REGULATION NO. 107. UNIFORM PROVISIONS CONCERNING THE
 APPROVAL OF DOUBLE-DECK LARGE PASSENGER VEHICLES WITH
 REGARD TO THEIR GENERAL CONSTRUCTION

PROPOSAL OF AMENDMENTS TO REGULATION

TRANS/WP.29/837

DRAFT SUPPLEMENT 2 TO REGULATION No. 107

"5.7.4. Access to escape hatches

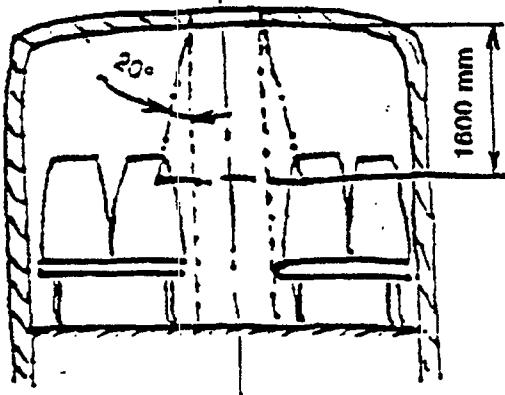
Paragraph 5.7.4., amend to read:

5.7.4.1. If one or more escape hatches are fitted in the roof, at least one escape hatch shall be located such that a four-sided truncated pyramid having a side angle of 20° and a height of 1,600 mm touches part of a seat or equivalent support. The axis of the pyramid shall be vertical and its smaller section shall contact the aperture area of the escape hatch. Supports may be foldable or movable provided they can be locked in their position of use. This position shall be taken for verification.

5.7.4.2. When the structural thickness of the roof is more than 150 mm, the smaller section of the pyramid shall contact the aperture area of the escape hatch at the level of the outside surface of the roof."

Figure 11

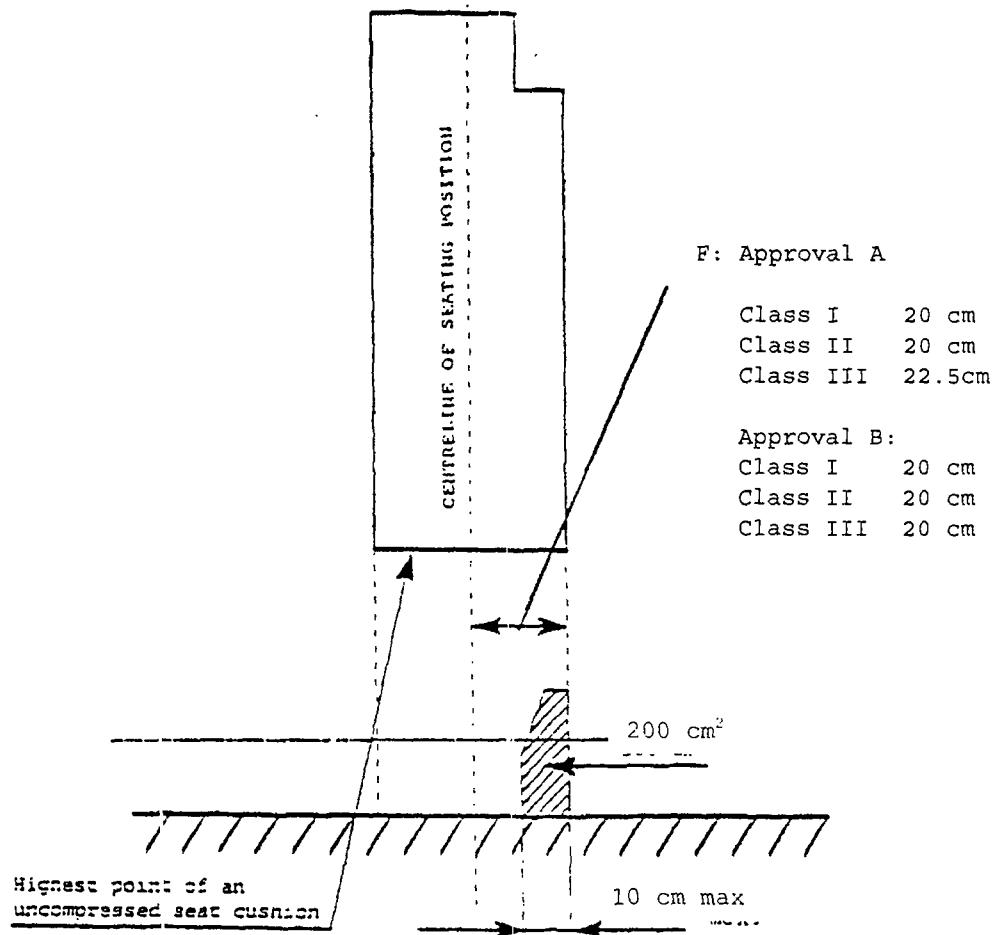
Annex 3, figure 11, replace by the following figure:

PERMITTED INTRUSION IN LOWER PART OF PASSENGER SPACE
(See paragraph 5.7.9.6.2.3.)

"Figure 16

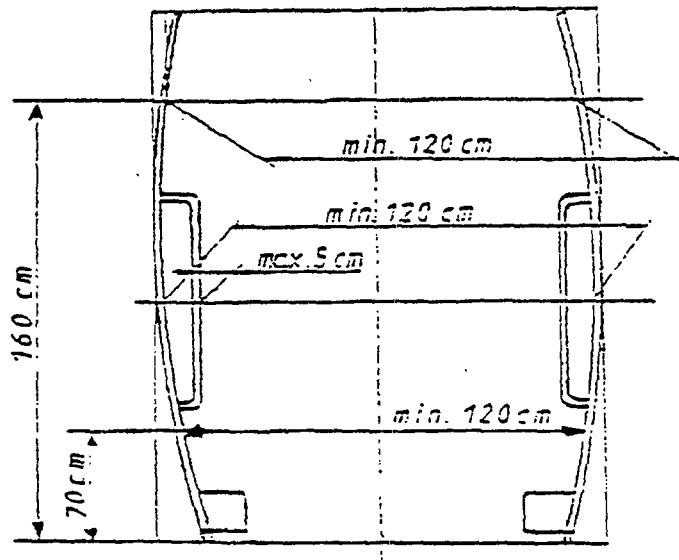
" the following minimum dimensions (see also annex 3, figure 16) ."

"... The required width shall be ensured in the height of 70 to 160 cm related to the level of the first step (see annex 3, figure 16)."

Annex 3, insert a new figure 16, to read:

SERVICE DOOR DIMENSIONS
(see paragraph 5.6.3.1.)
